# HISTORIC LANDMARK COMMISSION

## STAFF REPORT

**Trudell/Thompson Window Replacement  
PLNHLC2010-00057  
249 South 1100 East  
May 5, 2010**

INSIDE

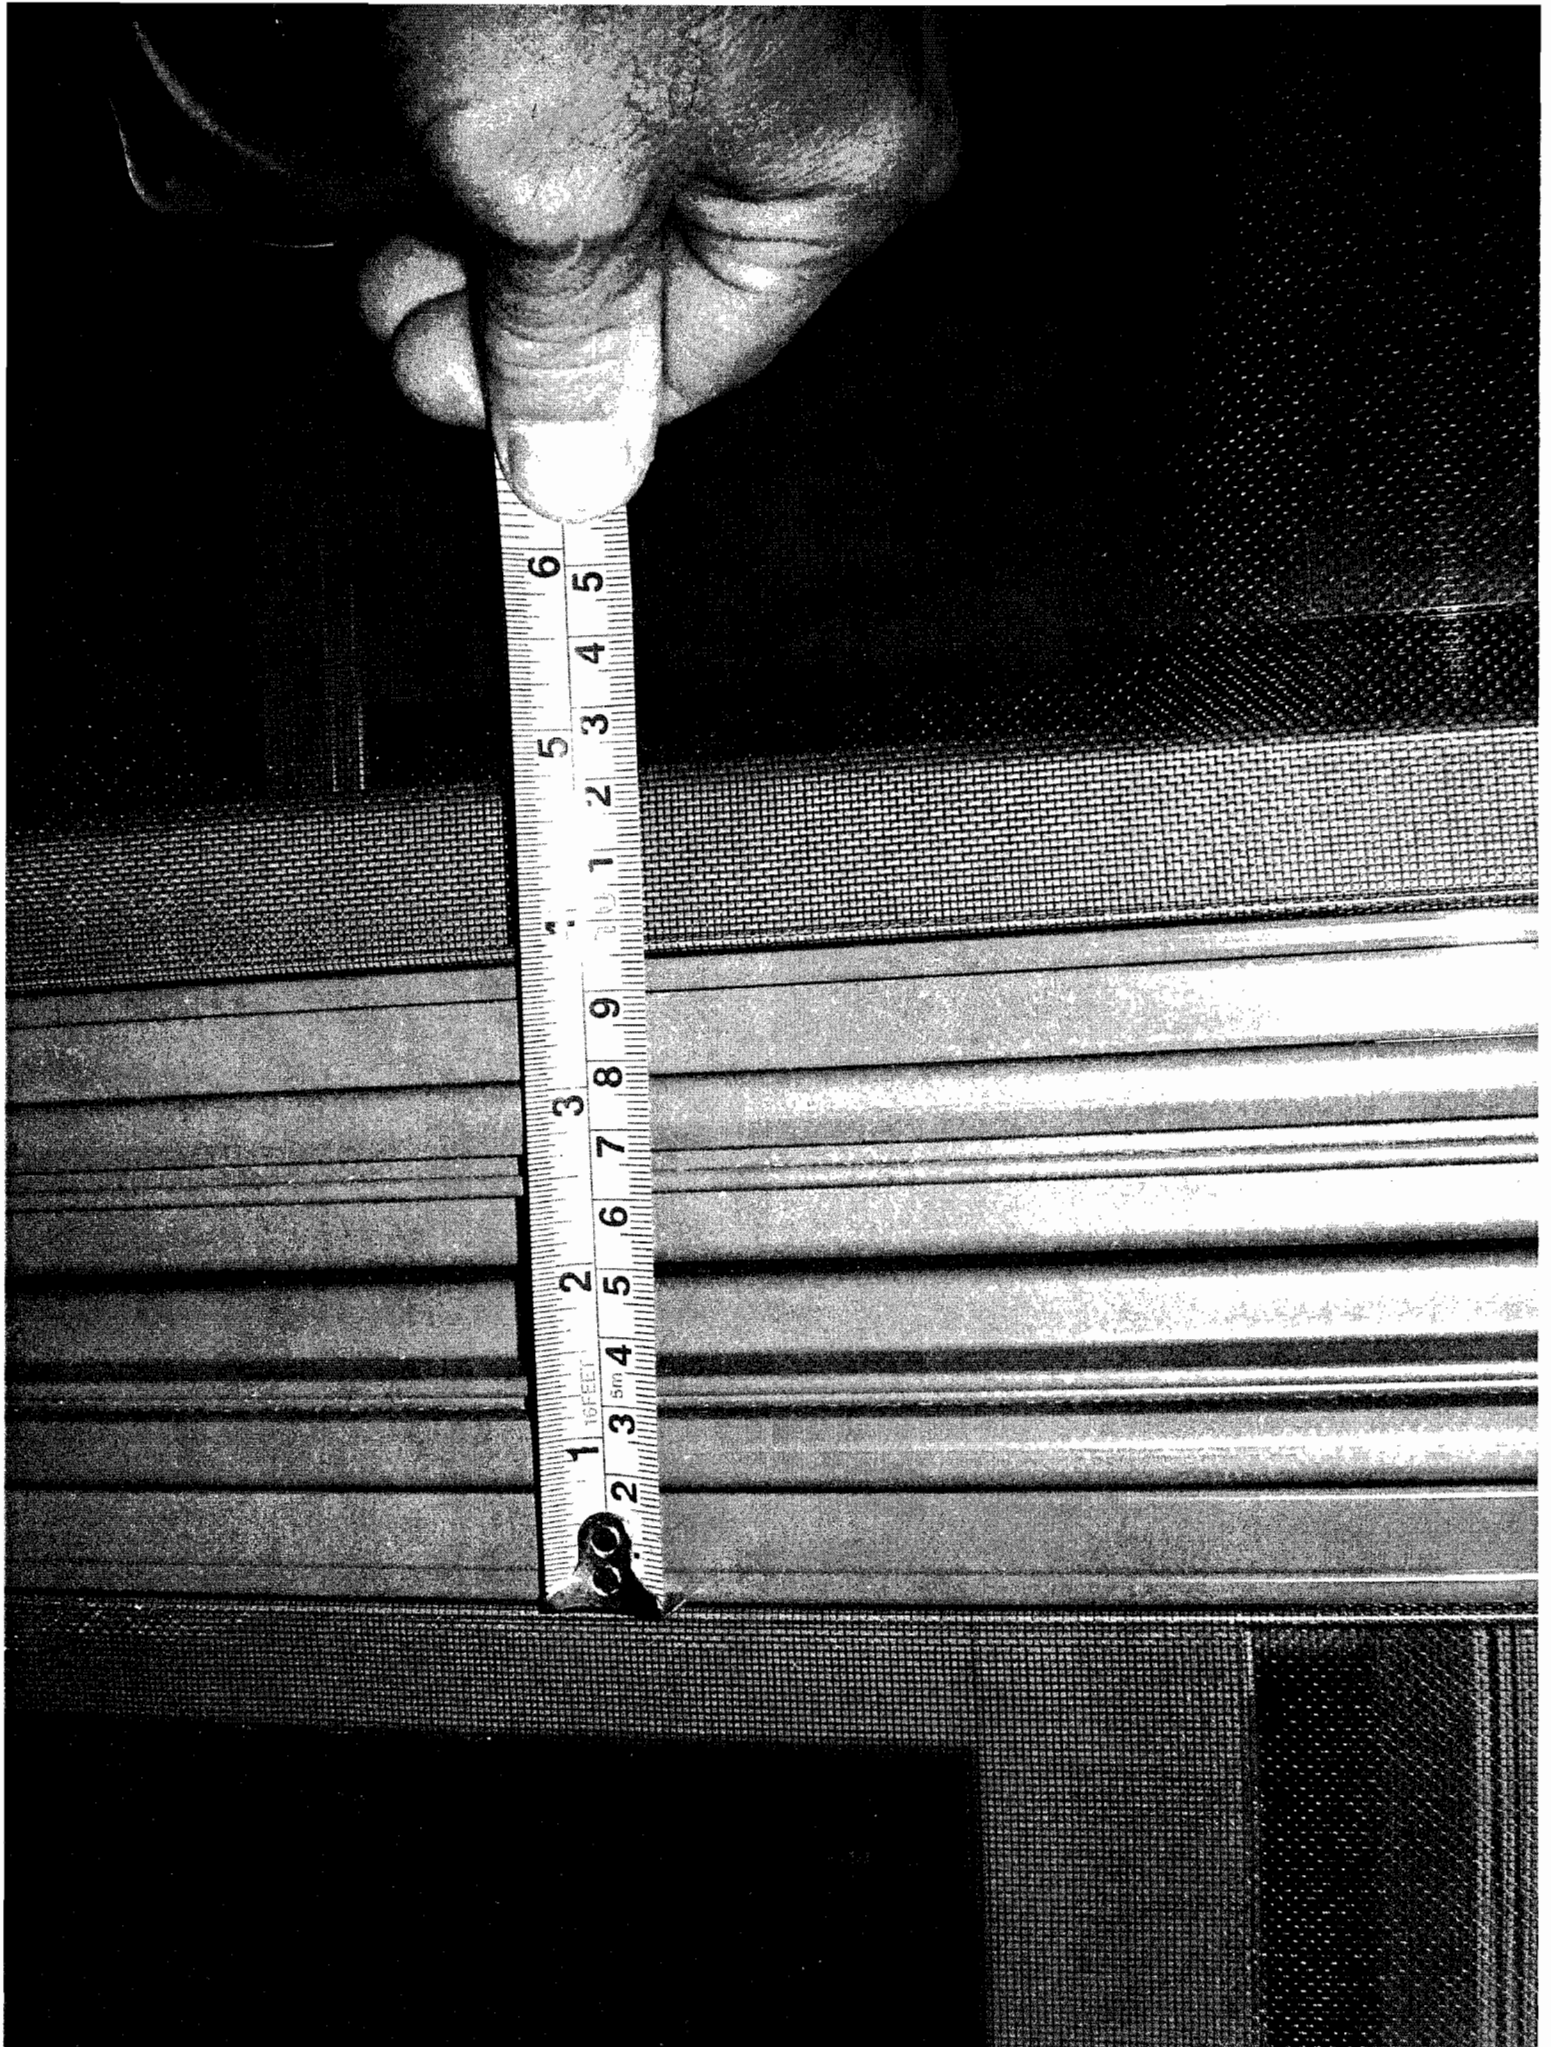
**Discussion for Standard 2:** As previously noted, the subject home has been significantly altered over the years, particularly the front façade. When considering the replacement of the existing windows on the front façade, Planning Staff asserts that the single or double-hung window configuration as shown in the attached historic photo from 1936, is an appropriate window style for the subject home. Planning Staff asserts that the proposed double-hung windows for the front façade honor the historic character of the structure. This type of window is typical of, and consistent with, the architectural style and age of the subject home. Photos of the existing and proposed front façade windows are attached for review (Exhibit C). Specification and technical information for Anderson Double-Hung Windows is also attached (Exhibit G).

Planning Staff's main concern with the proposed side-by-side double-hung windows is that there is no significant mullion feature separating the windows. Essentially, the proposed windows are separated by the width of the window frames. Typically, a more substantial mullion would separate side-by-side windows of this nature. Further, a window grid pattern is not evident on any of the historic photos that Planning Staff has been able to obtain. An internal grid (sandwiched between the double panes of glass) has been installed on the upper-level front façade windows. Planning Staff asserts that a grid pattern is not consistent with the historic characteristics of the windows that were in this home in 1936. Therefore, the grids should be removed from the newly replaced windows, and should not be included in any further replacement windows. To Planning Staff's knowledge, internal grid patterns are never appropriate for windows on the primary façade (and perhaps secondary or rear facades) for structures in the City's historic districts, nor have they ever been approved.

**Findings for Standard 2:** In general, the side-by-side double-hung windows installed, and those proposed, on the front façade retain and preserve the historic character of the subject home. The absence of a substantial mullion feature between these windows is inconsistent with the historic configuration of windows of this nature, and therefore somewhat detracts from retaining and preserving the historic character of this property. To be more historically characteristic, a substantial mullion feature is needed. Because of the lack of this feature in the windows installed and those proposed on the front façade, Planning Staff asserts that these windows do not meet this standard. Further, any simulated light grid pattern in the installed or proposed windows does not reflect, retain, or preserve the historic character of the home and should therefore be removed and/or eliminated as proposed. Finally, the picture window proposed on the north façade does not meet this standard, as it does not reflect, retain, or preserve the historic character of the property.

**Discussion of Standard 6 in relation to the front, north, and rear façade windows:** The double-hung windows chosen for the front façade generally meet the design criteria for replacement windows. The style is likely similar to the originals based on historic photos, and the profile of the windows generally meet the criteria as well. The window's wood composition material is one that has been allowed in the past and is therefore appropriate in this instance. To reiterate previous discussion, the issue with the proposed side-by-side double-hung windows on the front façade rests primarily with the lack of a substantial mullion feature, and the inclusion of a simulated divided-light grid pattern.

**Findings for Standard 6 in relation to the front, north, and rear façade windows:** In general, the windows installed, and those chosen for installation, on the front and rear facades of the home, meet Standard 6 based on duplications of features that are substantiated by historic pictorial evidence. The configuration of the front façade windows are somewhat problematic because of the lack of a mullion

**Exhibit D –**  
**Photos – North Facade**

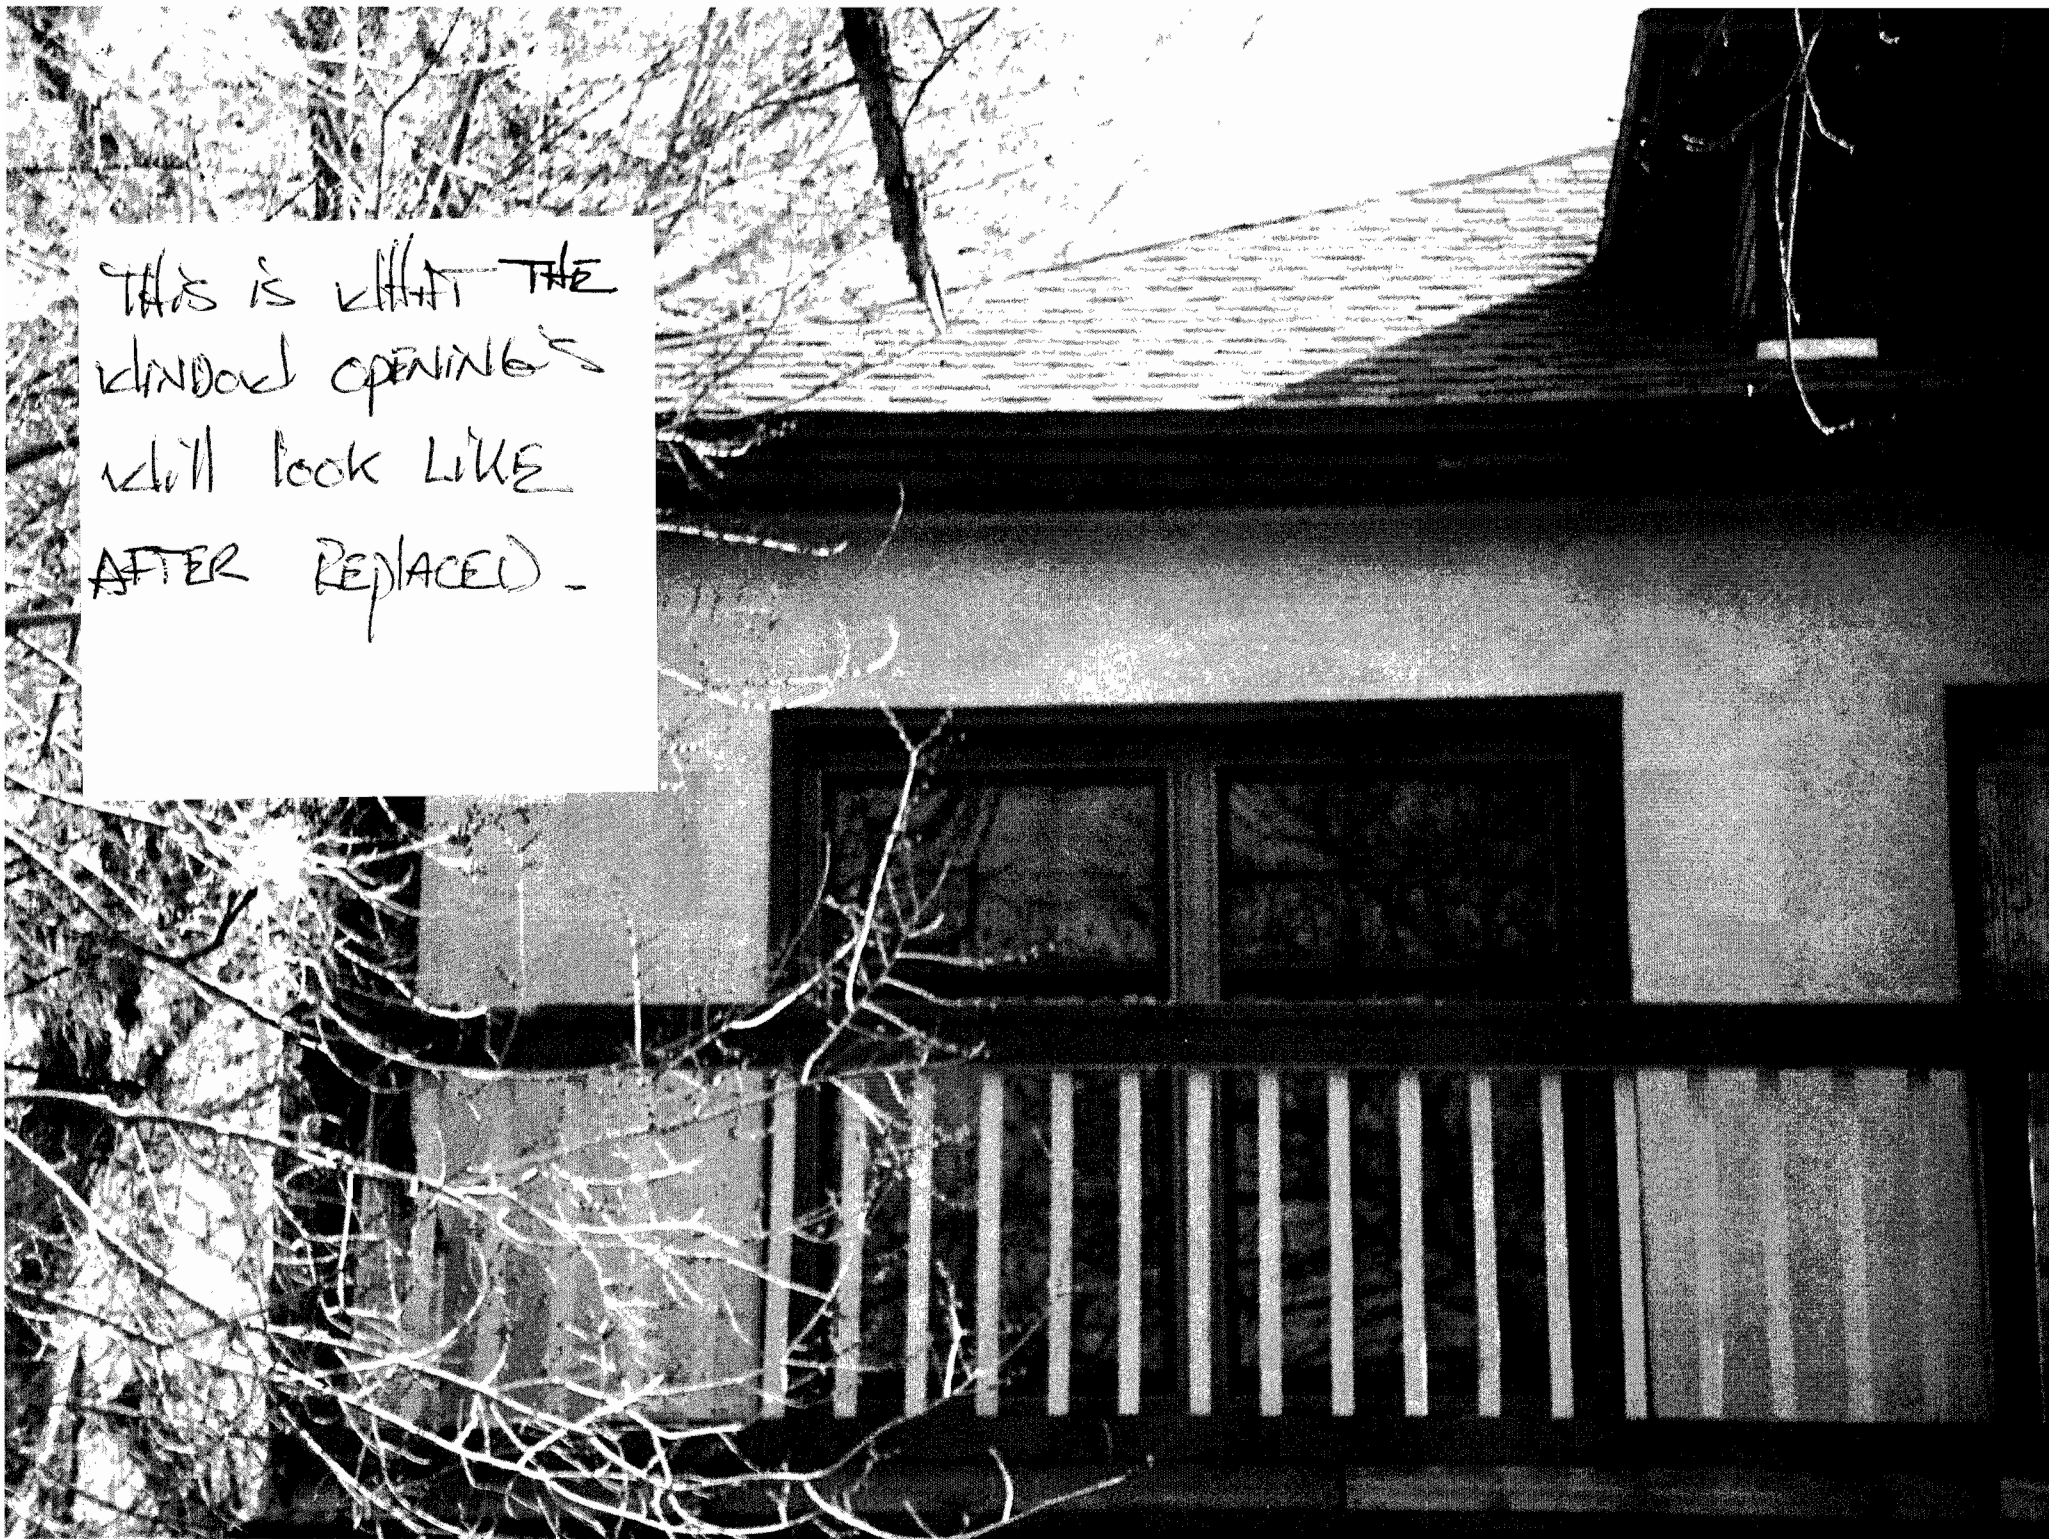
The proposed picture window on the north façade of the home does not honor the historic character of the property (Exhibit D). Instead of a picture windows in this location, Planning Staff has suggested either two side-by-side double-hung windows with a mullion, or a window with a transom. For reference, technical specifications for Anderson Picture Windows are attached (Exhibit H).

The proposed picture window on the north façade does not meet criteria 3.5, as it is highly unlikely that the original window in this location was a picture window. It is more likely that the window was of the single or double-hung variety, hence Planning Staff's suggestion that this type of window be used in this location.

feature and the inclusion of a simulated divided-light grid pattern. The picture window chosen for the north façade does not meet this standard.

**Exhibit E –**  
**Photos – Rear Facade**

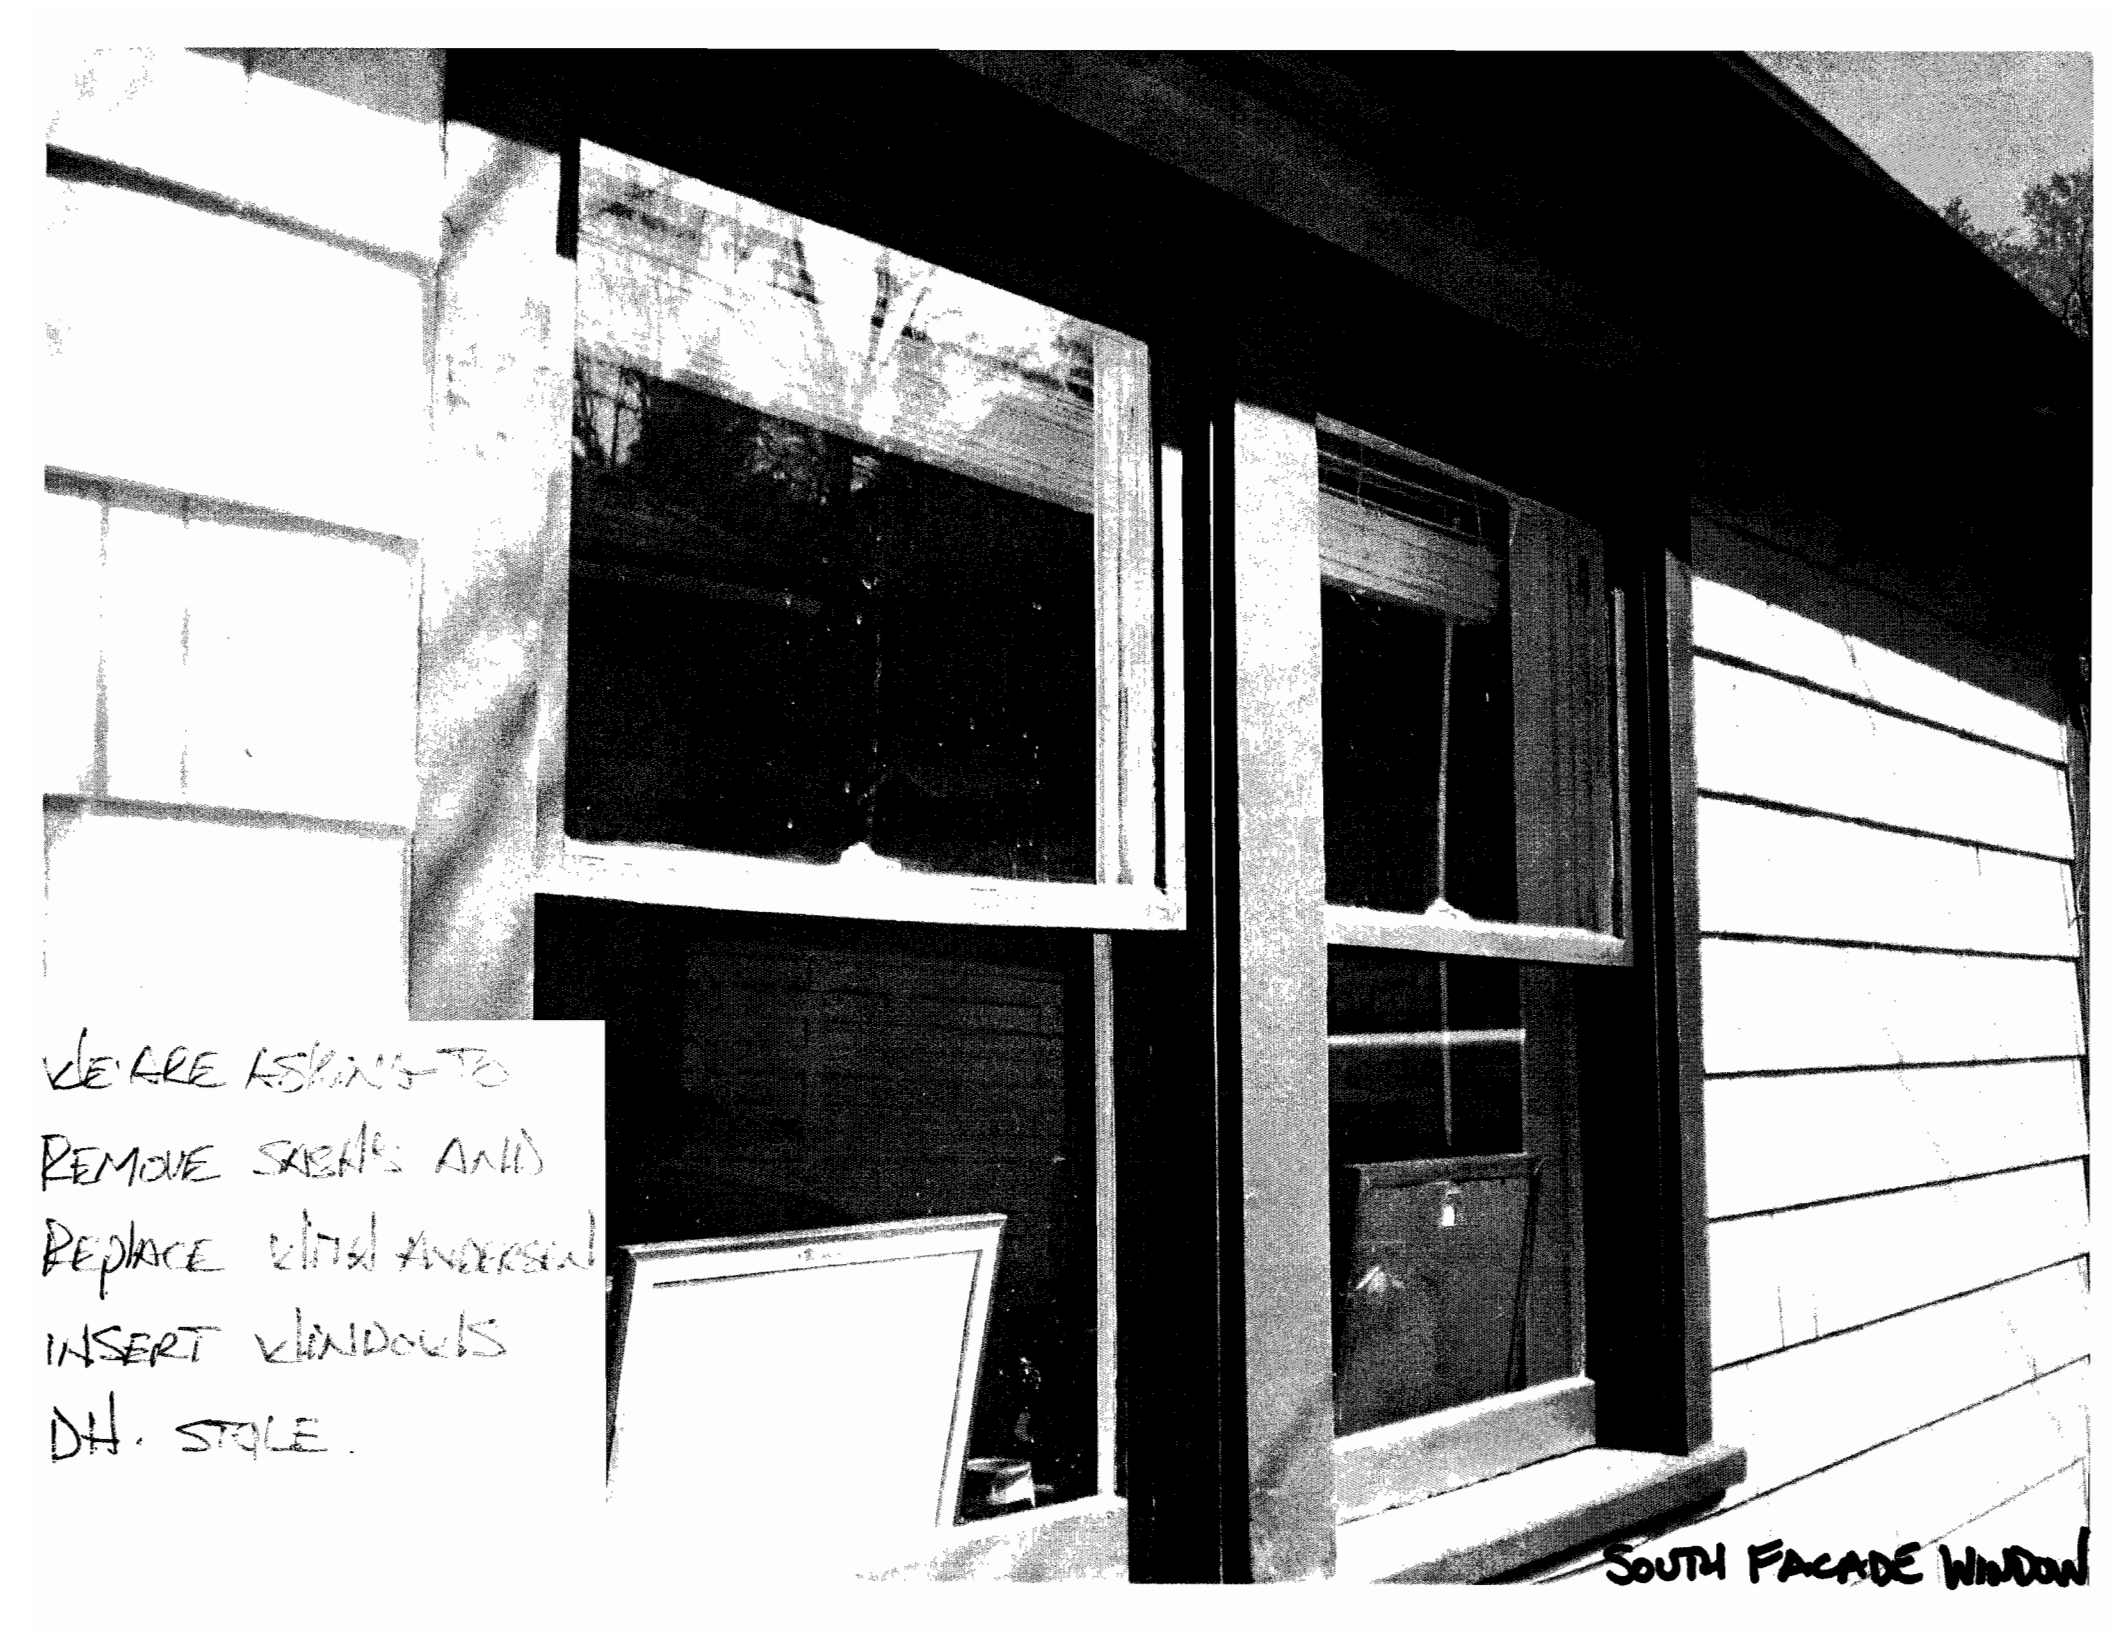
The windows that were recently replaced on the rear of the home, in general, retain and preserve the historic character of the property (Exhibit E). The new awning window and the new double-hung window are of the same configuration as the windows shown in the attached photograph from 1980. The new picture window is inconsistent with the more characteristic single or double-hung window pattern, however since it is on the rear of the building and not visible from the street, Planning Staff asserts that this particular window is acceptable.

The windows that were installed on the upper story of the rear façade, in general, do retain the historic character of the property and therefore should be allowed to remain.

The rear façade windows in general meet these criteria as well. As previously noted, a single or double-hung window would have been a better choice for the picture window that was installed, but the picture window appropriate in this particular case because of the location.
